DESIGN/DEVELOPMENT REVIEW COMMISSION
DESIGN REVIEW DISTRICT
CONSENT AGENDA
EVALUATION SHEET
Case # 3

ADDRESS: 15 Gibbes Court

NATURE OF REQUEST: Request Certificate of Design Approval for garage demolition and new construction

Summary
Structural Evaluation
of
15 Gibbes Court
Columbia, SC

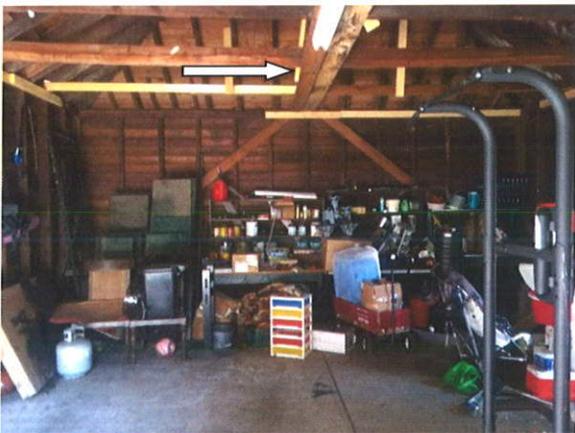
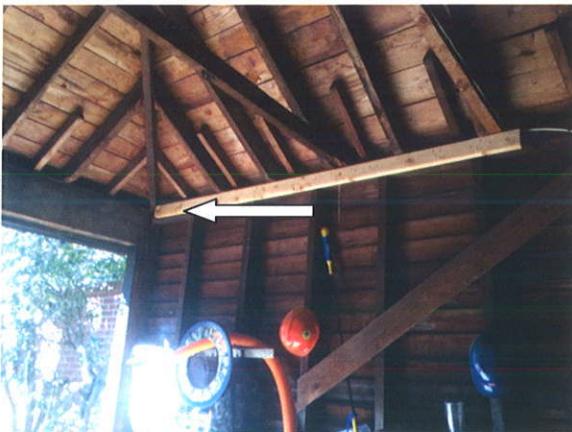
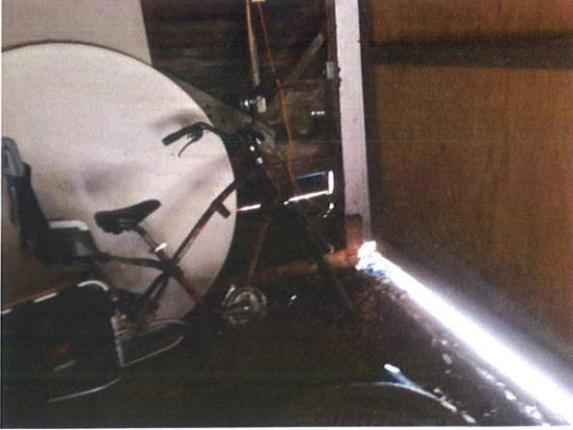
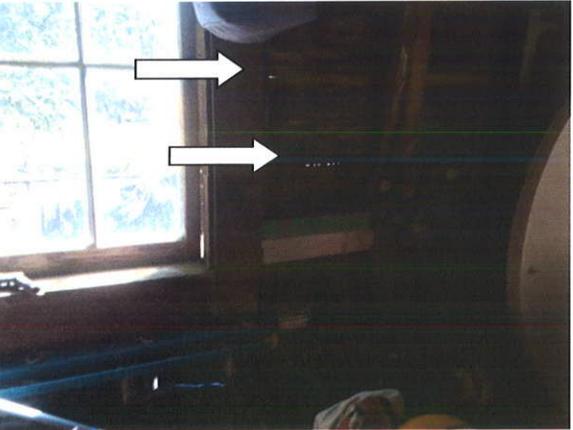
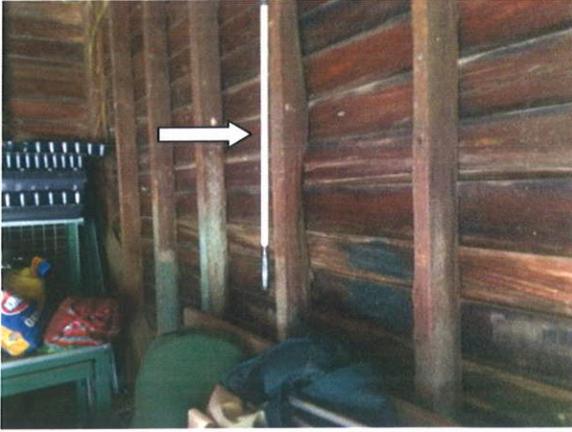
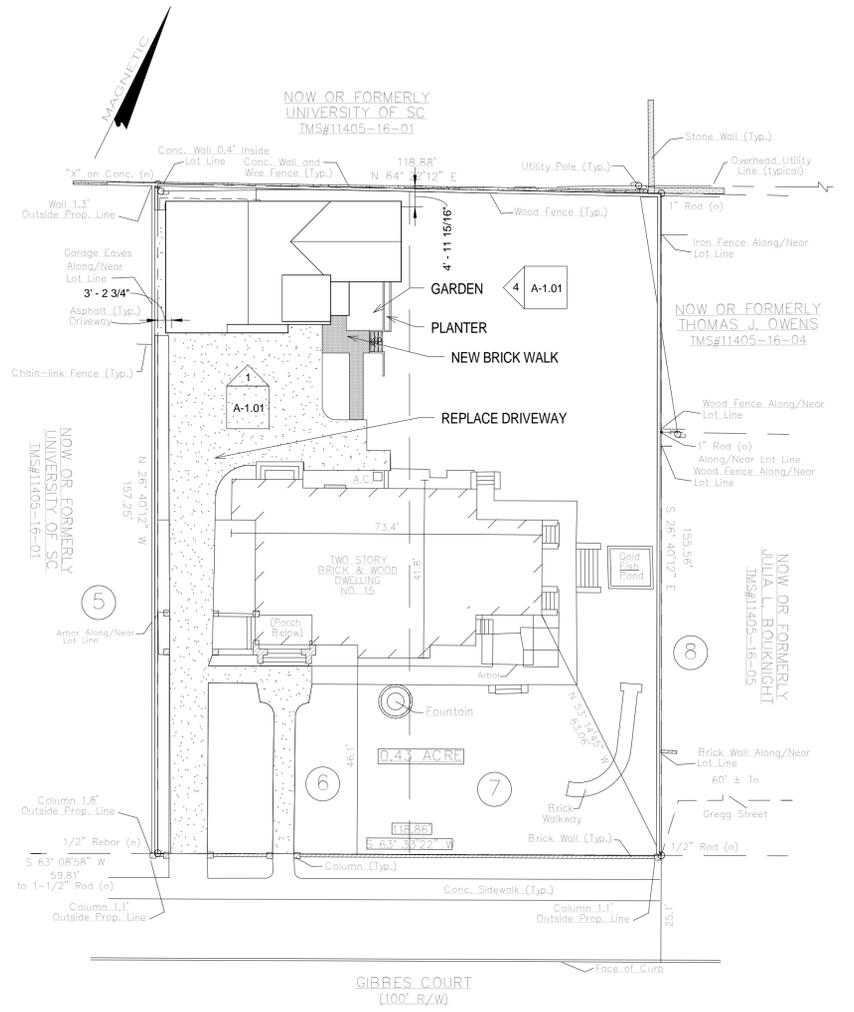
1. Numerous areas of termite damage were noted. Those locations are noted to be but not limited to the stud wall at the right rear (See photos 1 and 2), the top front corner of the window at the left side (See photo 3), the top front corner of the window at the right side (See photo 4) and at the top of the window at the right side. (See photo 5).

2. There were no collar ties noted on the existing roof rafters. There are a few rafter tie members noted, however, some of them were not connected properly to the existing rafters. Numerous roof rafters were noted to not have the required rafter and collar tie connections (See photos 6 and 7).

3. The existing roof rafters at the front of the hip were noted to have new pieces of timber scabbed to the sides of the original rafters to be an extension. It appears that the original rafter may have had problems in the past, which required a scab repair and extension (See photo 8).

4. (2) Wooden beams, which were noted lying on their flat face, were used to shore the existing roof rafters. (See photos 9 and 10). Severe sagging/deflection was noted at the shoring locations along the flat beam (See photo 11).

5. No hold downs or hurricane ties were noted. (See photos 12 – 15)
6. Numerous holes were noted in the existing wood siding. These locations were noted but not limited to the middle bottom of the left wall (See photos 16 and 17), the middle of the rear wall (See photo 18), the left rear corner (See photo 19), the right rear corner (See photo 20), the middle of the right wall (See photo 21) and the front right corner (See photo 22).

7. A hole was noted in the roof at the front of the ridge. (See photos 23 and 24)
8. A large hole was noted at the overhang at the right rear of the garage. It was reported by the owner that a tree grew through the roof and was previously removed. (See photo 25)

9. The window at the right side of the garage was noted to have multiple gaps around the frame. (See photos 26 and 27)
10. A warped 3x stud was noted at the rear area of the right wall. (See photo 28)

Based on the field observation and the field condition, it is in our opinion that the current garage structure is not structurally sound.

1 Proposed Front Elevation
A-1.01/ 1/4" = 1'-0"

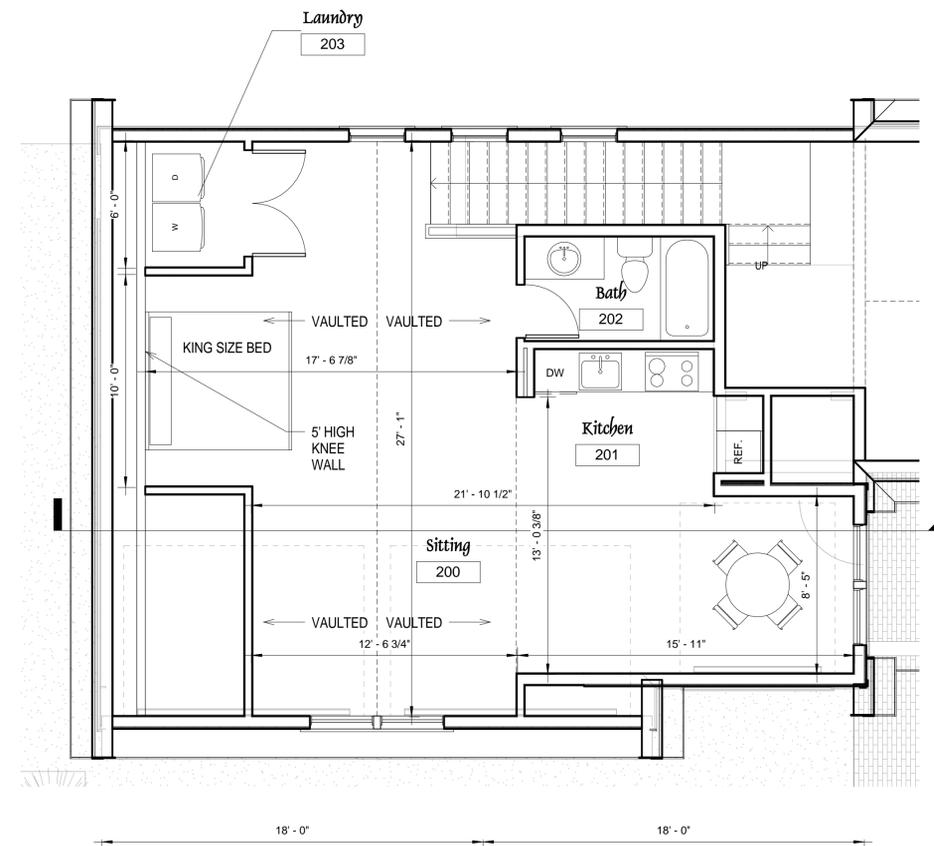
The main entrances visible to the public right of way are large garage doors, which are consistent with the garage that is being removed and with older garage patterns.

The rhythm of openings is consistent with the nearby home. The garage doors on the first floor are consistent with the typical rhythm for the area and a central doubled window in the upper floor of the façade is the only fenestration that will be visible to the public right of way. It will not be highly visible but it is appropriate for the area.

The roof is a front gable shape, which is compatible with the area.

Windows: The two front, visible windows in the garage will be wood or aluminum-clad with no muntins, to match the existing historic windows on the house.

Walls: The garage siding shall be horizontal cement fiberboard. The applicant did not specify the reveal of the siding, but staff would recommend a reveal consistent with historic wood siding in the district.

Door: The only visible doors will be the two garage doors in the façade, which appear to be a design consistent with era of the associated house.

Staff recommends approval of the new construction as it complies with Section 6 of the guidelines, with all details deferred to staff.
